Bullatale inlet regulator replacement

Addendum Review of Environmental Factors

July 2024

Figure 3-1 Proposed modification - Bullatale Inlet Regulator construction footprint

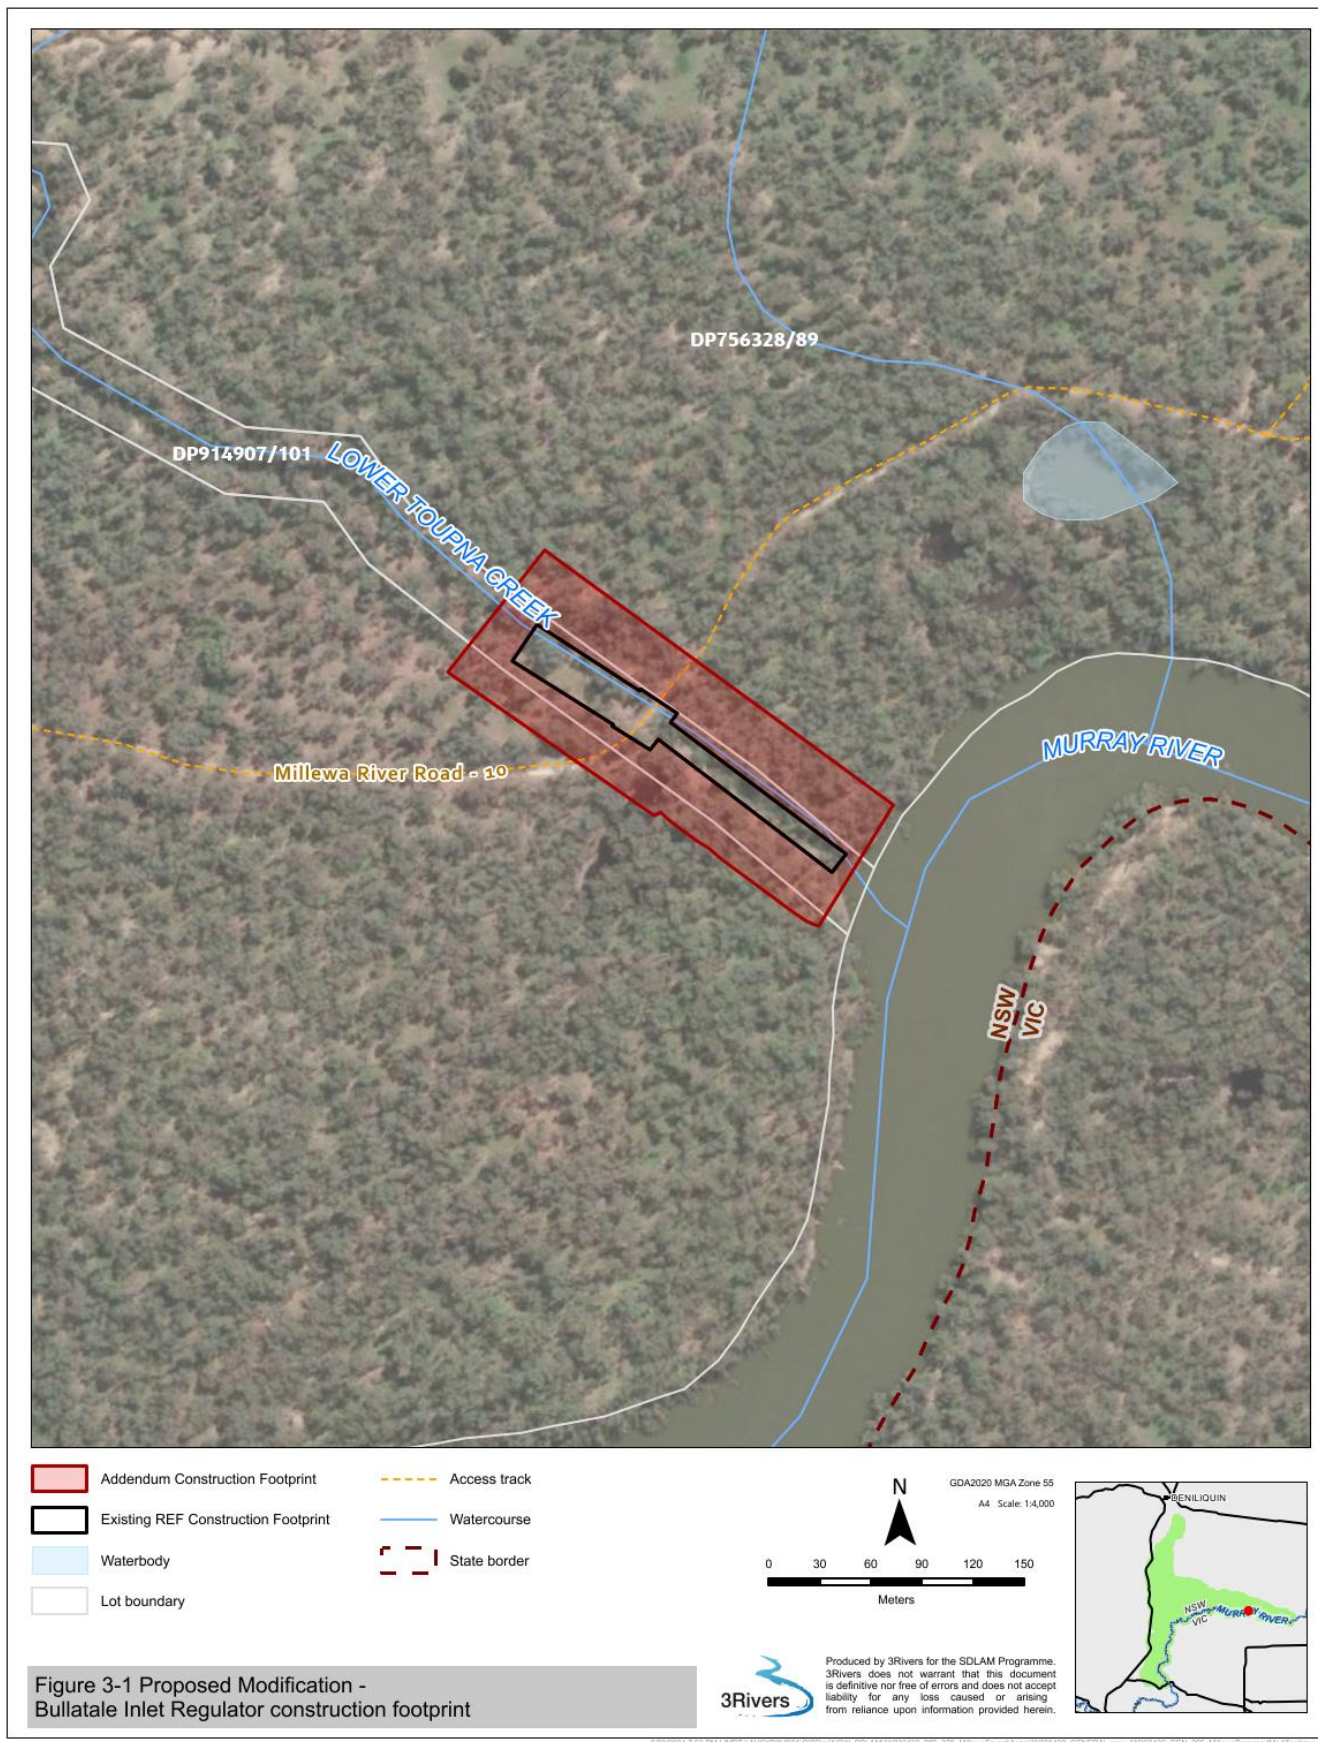
The proposed modification would slightly expand the construction footprint with an extension of about 15 metres by 25 metres required around the existing footprint. This would increase the overall construction footprint for the Project to approximately 260 metres by 95 metres, with a total Project construction footprint area of about 2.27 hectares (an additional area of about 1.85 hectares). This increase is required to safely allow for construction vehicle movements and general construction activities and is associated with an increase in vegetation clearance and ground disturbance. The addendum construction footprint would accommodate the proposed new infrastructure, existing infrastructure to be replaced, and adjoining areas for laydown and storage of plant and equipment, and stockpiles of materials and spoil.

As noted in the existing REF, a temporary work area with dimensions of about 16-metres by 35-metres is proposed in the cleared area above the buried pipelines. The proposed modification would expand this temporary work area, with a 15-metre by 25-metre extension applied around the existing construction footprint to provide adequate space for construction vehicle movements and general construction activities as shown in Figure 3-1.

Figure 3-2 Section view of Bullatale Supply Channel Inlet Regulator

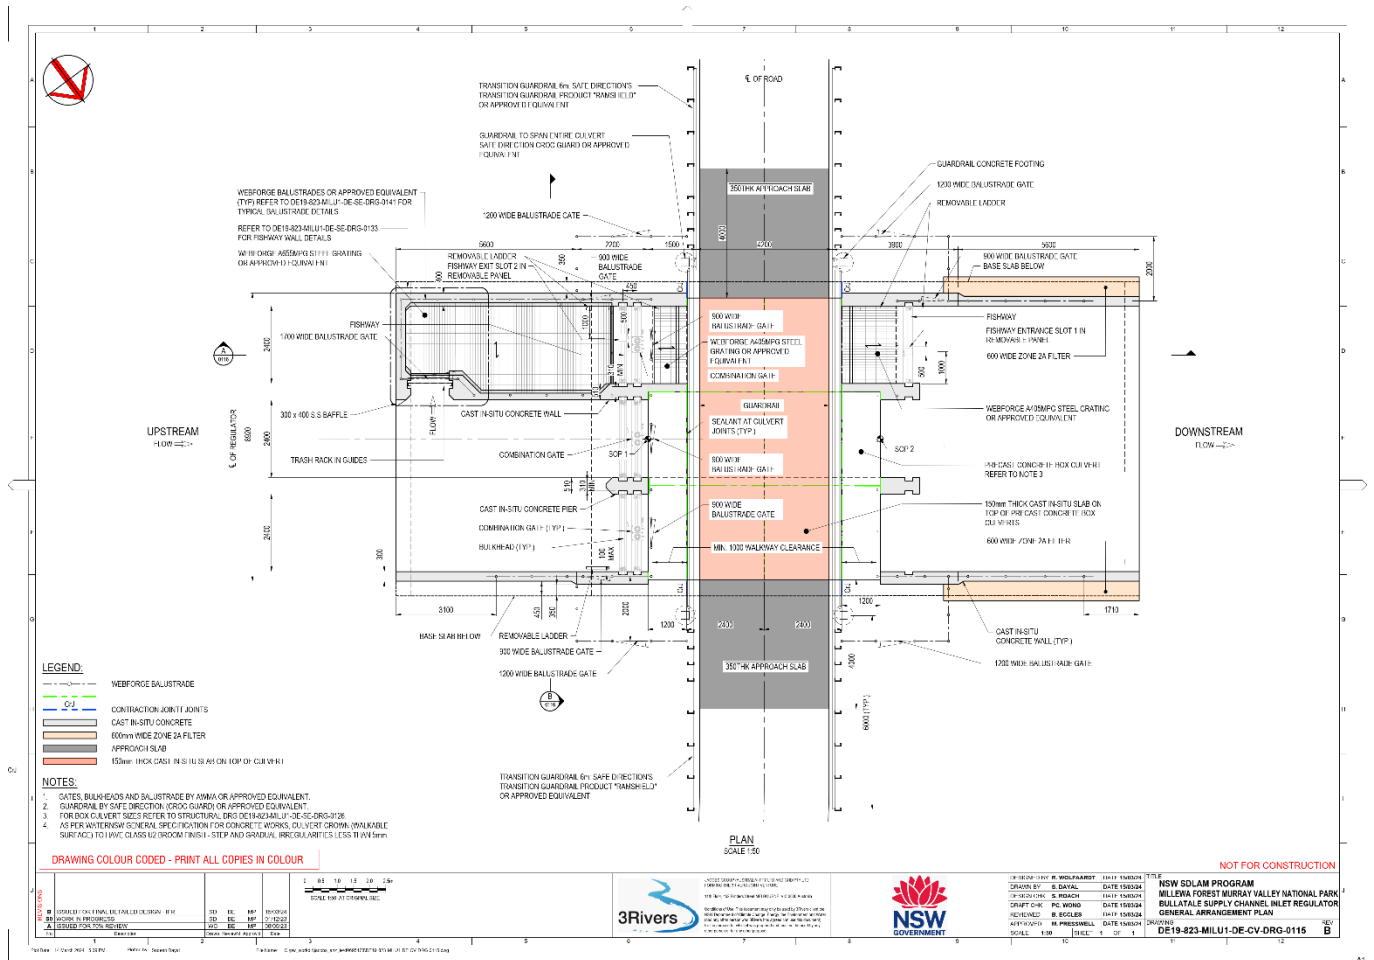
Following the preparation of the existing REF, minor changes to the proposed design of the regulator have occurred as the detailed design has progressed. The proposed changes to the regulator are consistent with the objectives and requirements described in the existing REF at Section 3.2. The proposed design generates minimal additional environmental impacts and does not require mitigation measures beyond those already provided in the existing REF. The proposed design would provide minor improvements in the operational functionality of the structure. A section view of the proposed regulator design is provided in Figure 3-2 below.

The design changes proposed as part of this Addendum REF are:

- Use of three combination gates compared to a single combination gate and two penstock gates: Combination gates allow for increased operational flexibility to control flows and improved fish passage through the regulator gates. This change also eliminates the need for a raised walkway to operate a gate and allows for safer operation.
